Access Compliance Report

Public Rights-of-Way

Intersection ID: 47164	Main Street: SOUTH_PARK_DR	Cross Street: FAIRVIEW_RD	Location: NW
ADA ID: D63C99F06A80	Ramp Type: Perp	Initial Pass/Fail: Fail	Overall Compliance: No
Severity Score: 12.5			
Codes/Mitigation Info/Possible Solution		Field Measurements/Component Compliance

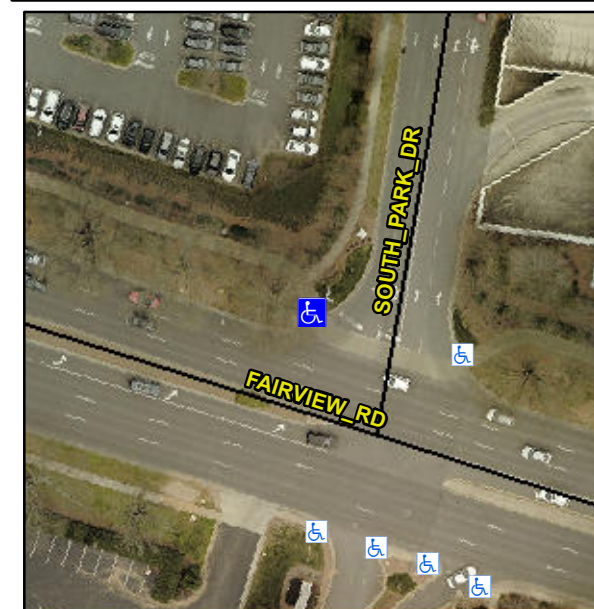
R304.5.3

Compliance	Description	Data	Compliance	Description	Data
N/A	Ramp Length (in)	79.0	Yes	Ramp Slope (%)	6.7
Yes	Ramp Width (in)	48.0	No	Ramp XSlope (%)	5.6
N/A	Flare Type LT	N/A	N/A	Flare Type RT	N/A
N/A	Flare Slope LT (%)	N/A	N/A	Flare Slope RT (%)	N/A
N/A	Flare Traversable LT?	N/A	N/A	Flare Traversable RT?	N/A
N/A	Landing Length (in)	N/A	N/A	DWS Provided?	N/A
N/A	Landing Width (in)	N/A	N/A	DWS Contrast?	N/A
N/A	Landing Slope (%)	N/A	N/A	DWS Length (in)	N/A
N/A	Landing X Slope (%)	N/A	N/A	DWS Full Width?	N/A
N/A	Landing Curb? (Y/N)	N/A	N/A	DWS Offset (in)	N/A
N/A	Shared Landing?	N/A			
N/A	Gutter Ponding?	N/A	N/A	Gutter Slope (%)	N/A
N/A	Gutter Lip Ht (in)	N/A	N/A	Gutter X Slope (%)	N/A
N/A	Painted X Walk1?	Yes	N/A	Painted X Walk2?	N/A
	X Walk 1 Direction	To E		X Walk 2 Direction	N/A
N/A	X Walk 1 Width (in)	96.0	N/A	X Walk 2 Width (in)	N/A
	X Walk 1 Slope (%)	7.2		X Walk 2 Slope (%)	N/A
	X Walk 1 X Slope (%)	6.1		X Walk 2 X Slope (%)	N/A

Remove & Replace Entire Ramp.
